Subject: CHIRP NOISE FROM REAR SHOCK ABSORBERS	Bulletin No: 02-003/14
	Last Issued: 09/18/2014

2014 CX-5 vehicles with VINs between JM3 KE ***** 387092 and JM3 KE ***** 490721 (produced before June 06, 2014)

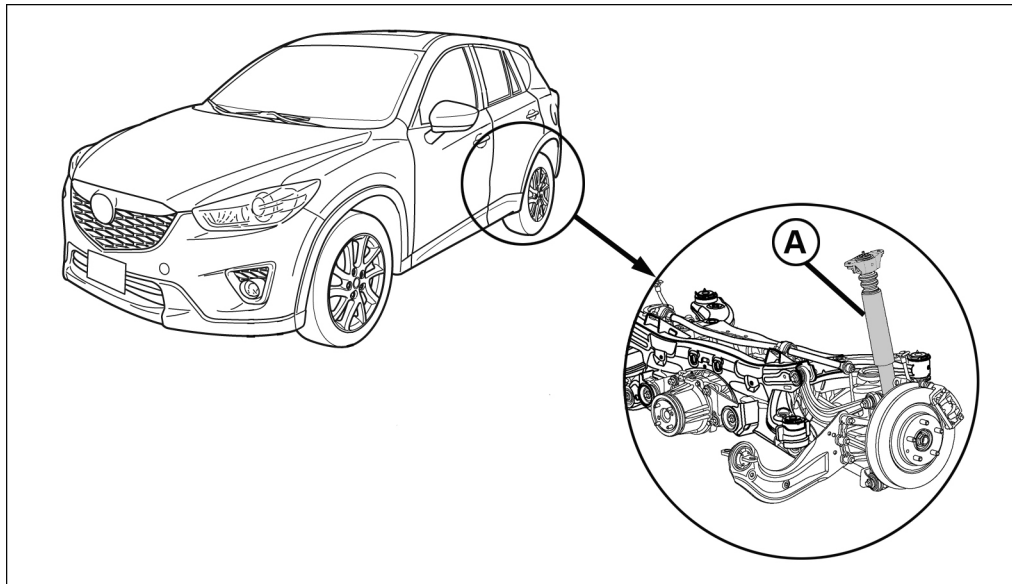
Some vehicles may exhibit a chirp noise from the rear shock absorbers (A) when driving on a rough road or passing over a speed bump. Visual inspection of the shock absorbers show no external damage or oil leakage.

1. Verify customer concern.
2. Replace the rear shock absorber. Refer to MS3 online or Workshop Manual (section 02-14 REAR SHOCK ABSORBER REMOVAL/INSTALLATION).

Part Number	Description	Qty.	Notes
KR27-28-910B	Rear Shock Absorber	1 or 2	Only replaced the affected side
